DEVELOPMENT OF DRAFT CONSTRUCTION SAFETY STANDARDS FOR EXCAVATIONS

DEVELOPMENT OF DRAFT CONSTRUCTION
SAFETY STANDARDS FOR EXCAVATIONS

NBSIR 83-2693

This section is laid out in a horizontal format which provides for the simultaneous presentation of four columns of information contained on facing pages. On the left hand page, the far left column contains the text of the input document. The next columns, also on the left hand page, includes any suggestions or comments which were produced in the industry workshops relating to the corresponding portion of the text. On the right hand page, left to right, are recommendations and suggestions made as a result of specific industry input, and a column containing an explanation of the recommendations.

Figure 2. Allowable configurations of sloped excavations (cases II, III, and IV are for short-term excavations)

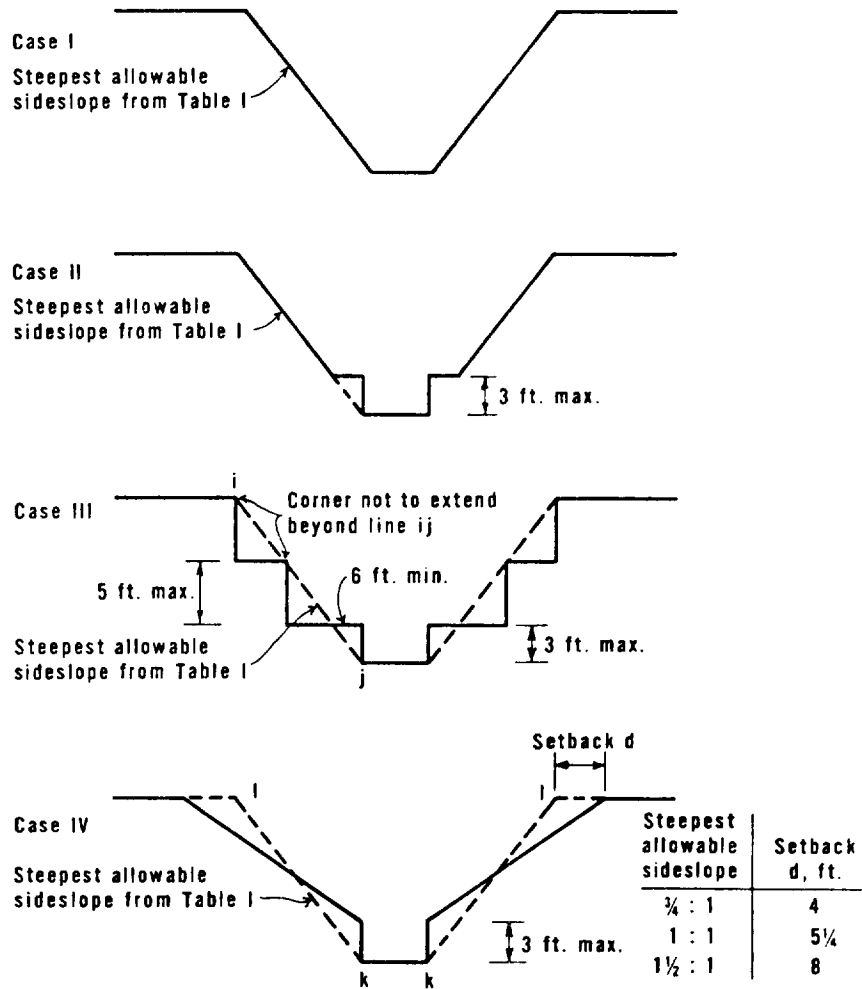
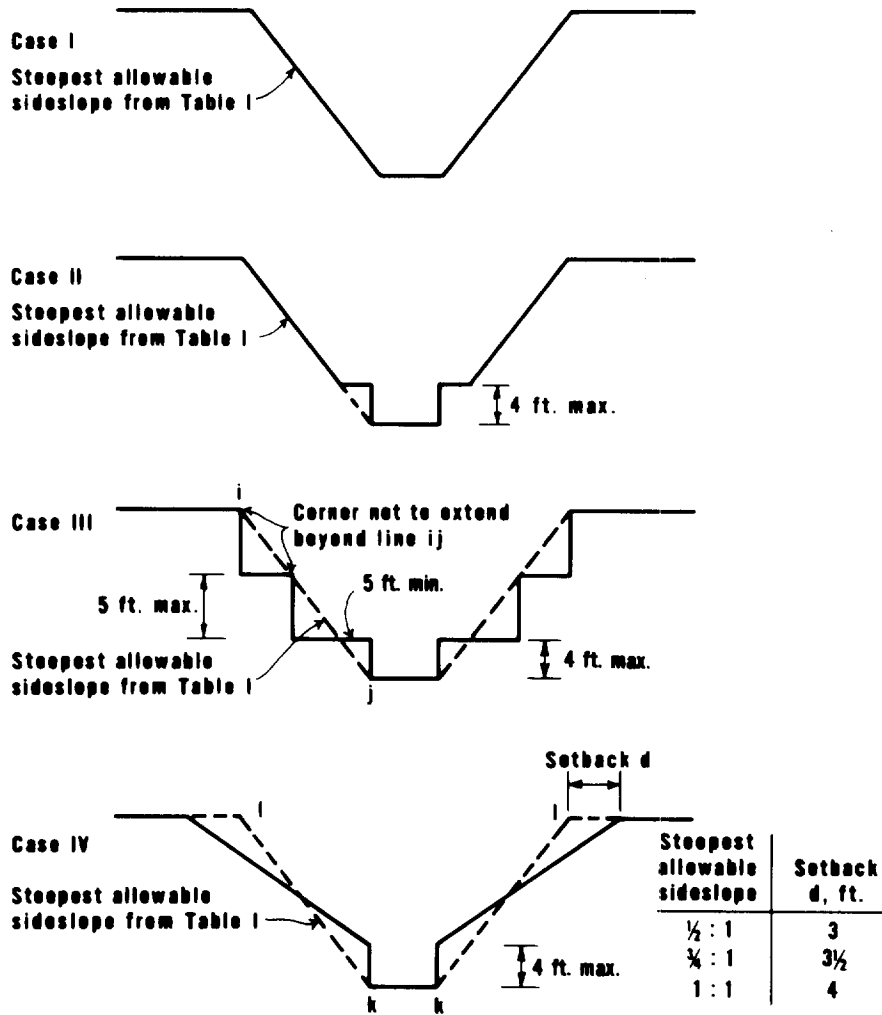
In the Dallas workshop, it was suggested by some contractors to increase the bank to 5 ft (workshop memo). AFL-CIO recommended to leave the allowable height at 3 ft. The point was made that if a large pipe is laid it would provide workers protection against collapse of the bank next to the work area.

6. Page 12. Figure 2: Should the allowable bank next to the work area in Cases II, III and IV be increased to 4 ft? Should "Case IV" be limited to excavation by trenching machines?

The revised sketch is a suggestion rather than a recommendation. It is recommended that industry try to reach agreement on the height of the allowable bank.

Figure 3. Determination of Adjusted Depth

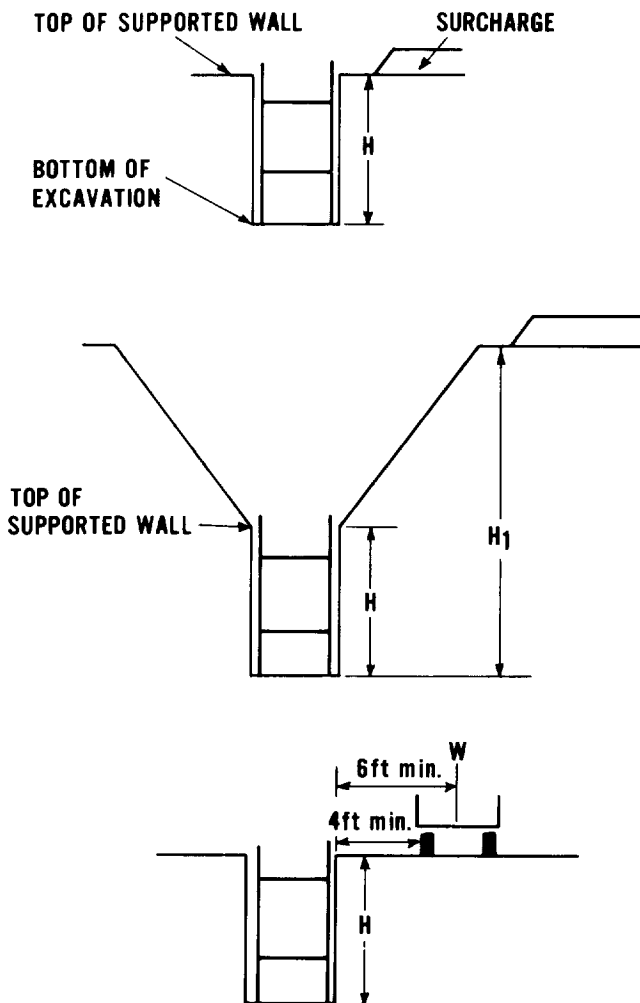
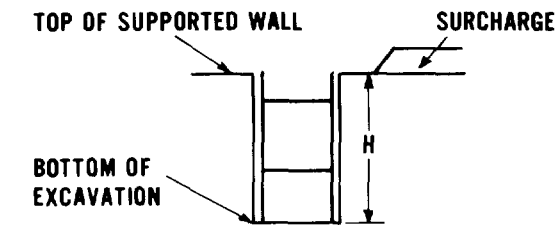
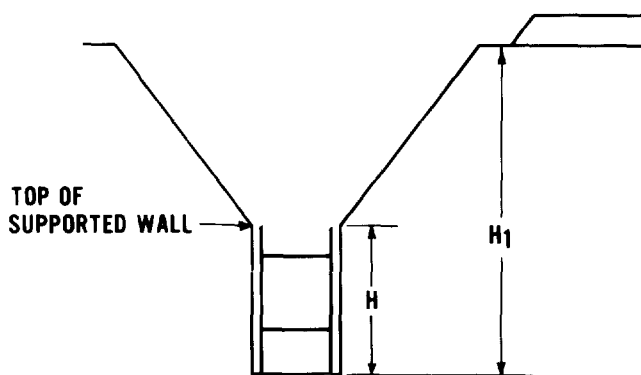
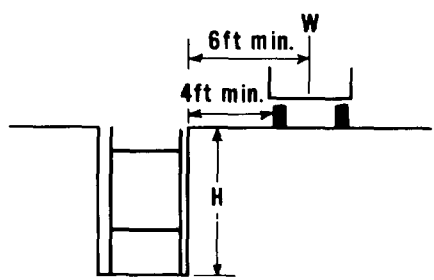
(4)(i) Even though b. and c. require some skill, their application should not be too difficult for a competent person to handle. The alternative of a need to consult a qualified person who is not on the job is even less attractive. The AFL-CIO suggestion of increasing the surcharge requirement in a., and in return eliminating b. and c., would mean in practice that in case b., a backslope of maximum 4 ft. height (H_1 in figure 3b = 4 + 4 ft) could be allowed, and equipment of maximum 20,000 lb. With higher backslope and heavier equipment, an engineer (qualified person) would have to be consulted. If this is acceptable, OSHA could go that route.

TABLES 2 and 3 NO CHANGE RECOMMENDED
